Final Environmental Impact Statement

FINAL ENVIRONMENTAL IMPACT STATEMENT For THE MINNESOTA URBAN BALLPARK

Downtown Minneapolis Hennepin County, Minnesota

RGU and Proposer: Hennepin County

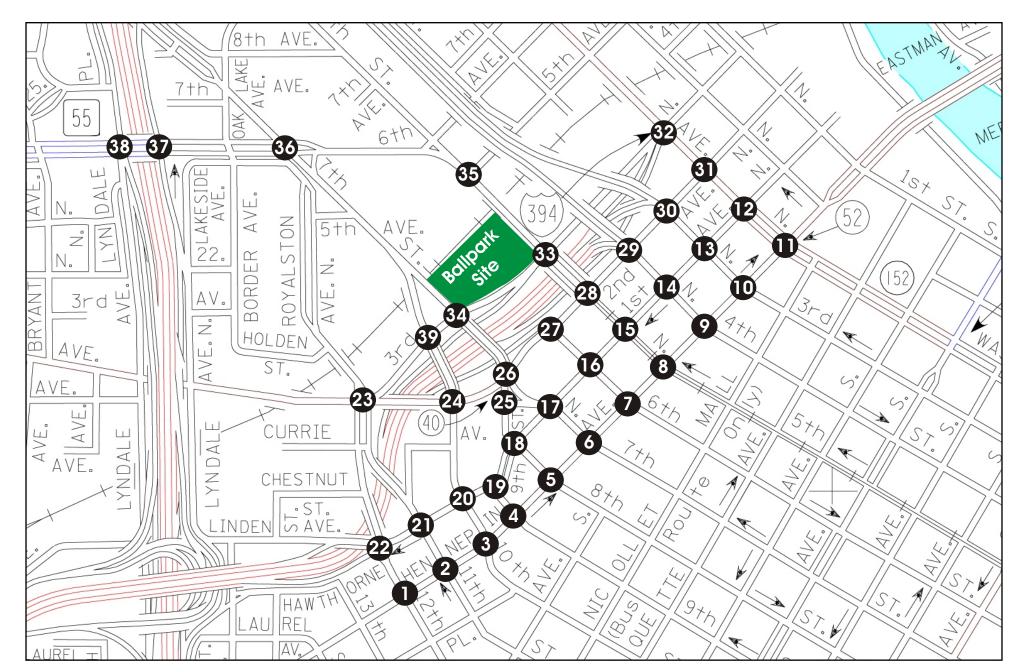
The intersection numbering system shown on Figure 3-2 needs to be consistent with the intersection numbers used throughout the document.

- **A** Comment noted.
- **B** Figure 3-2 in the Draft EIS has been updated in the Final EIS to correspond with the information in the tables.
- **C** Hennepin County (County) will continue working with the Minnesota Department of Transportation (Mn/DOT) to minimize the impact of event trips generated by the Ballpark on the freeway system.

- Figure 3-2 has been revised in the Final EIS to renumber intersections 35-40 as 34-39 to correspond with the intersections in tables 3-4 through 3-8.

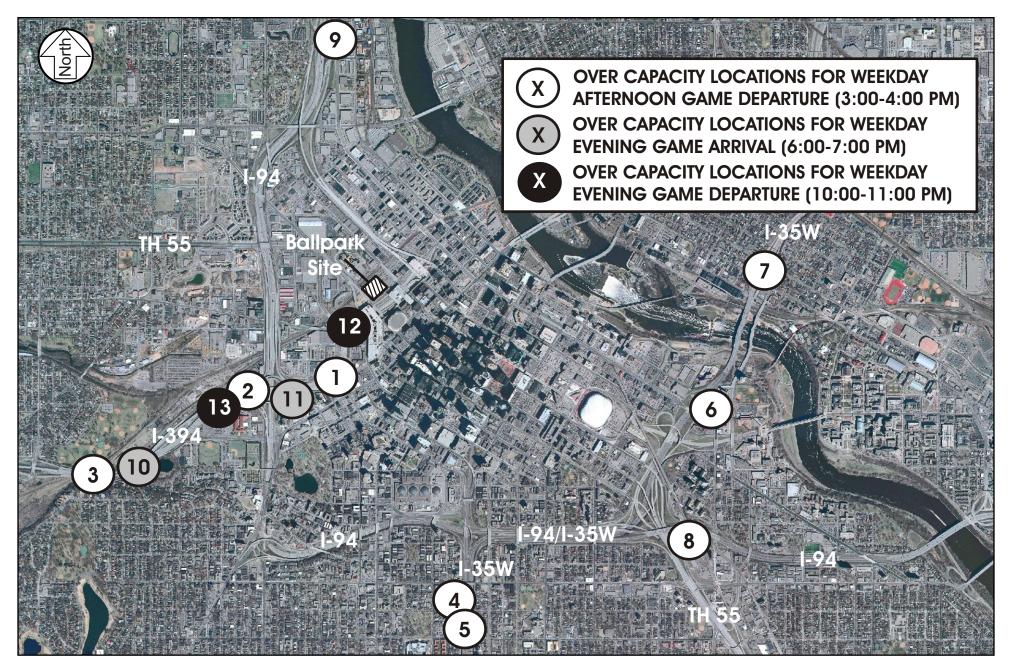
Page 3-29, Figure 3-3: the Interstates should be labeled on the figure.	l F
Page 3-31: Due to entry/payment congestion problems for evening games, in particular queues back onto I-394, payment should be retained at the exit/egress move.	G
Page 3-34: We strongly agree with and encourage the use of additional way-finding signing for vehicles, pedestrians and bicyclists.	н
Page 3-35: We recommend that the FHWA be included in the development of the Traffic Management Plan as part of the mitigation for traffic impacts.	1
Page 3-35: Improvement of parking ramp exit capacity should be reconsidered since neither surface streets nor freeway on-ramps and mainline capacity is available to improve ramp egress from Ramps A, B, and C.	J
Page 3-36: As another idea to promote later departure of event attendees, you might consider a reduced fee for exit, say 90 minutes, after the end of the game.	K
Page 3-36: We agree with and encourage implementation of a high quality remote parking program for day games and high attendance night games.	 L

- **F** Comment noted. Major freeway labels have been added to Figure 3-3 in the Final EIS.
- **G** Good event traffic management suggests collecting payment upon entry, because the event traffic arriving is more spread-out over time. The departure event traffic is more concentrated and it would likely take much longer to collect payment after an event. As part of the transportation mitigation measures, identification and upgrading of collection points will occur for entrances into Parking Ramps A, B and C.
